4396A-03

ADMINISTRATIVE INFORMATION

SERVICE NOTE CLASSIFICA	ATION:	
INFORMATION ONLY		
AUTHOR:	ENTITY:	ADDITIONAL INFORMATION:
TS	3355

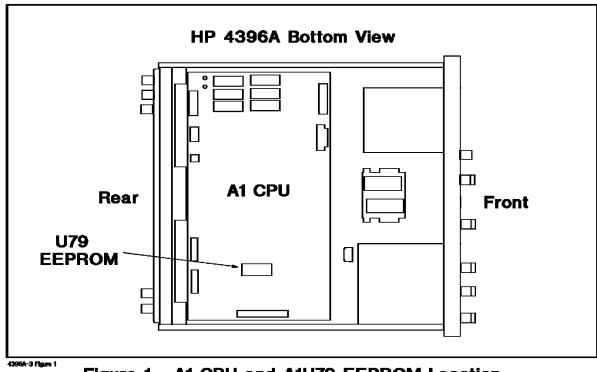
For the A1 CPU repair, only the A1 CPU flash memory version (pn 04396-66501, pn 04396-69501 for re-built assembly) is available. The replacement 04396-66511 ROM version is not available.

- 1. Remove the bottom cover from the unit.
- 2. Remove the defective A1 CPU from the unit. For the A1 CPU location, see Figure 1.

- 3. Remove the EEPROM from the A1U79 socket on the defective A1 CPU. See Figure 1 for the A1U79 location.
- 4. Remove the blank EEPROM from A1U79 socket on the new A1 CPU and insert it into the A1U79 on the defective A1 CPU.
- 5. Insert the EEPROM (removed from the defective A1 CPU in step 3) into the A1U79 socket on the new A1 CPU.
- 6. Install the new A1 CPU into the unit.
- 7. Reassemble the bottom cover.
- 8. Install the firmware into the unit. Use the firmware installiton kit for the revision indicated in the revision label on the rear panel. For the part number of the kit, see service note 4396A-01. The installation procedure is provided in the kit.

Whenever an A1 CPU (flash memory version or ROM version) is defective, replace it with a new A1 CPU of flash memory version (pn 04396-69501 for re-built assembly).
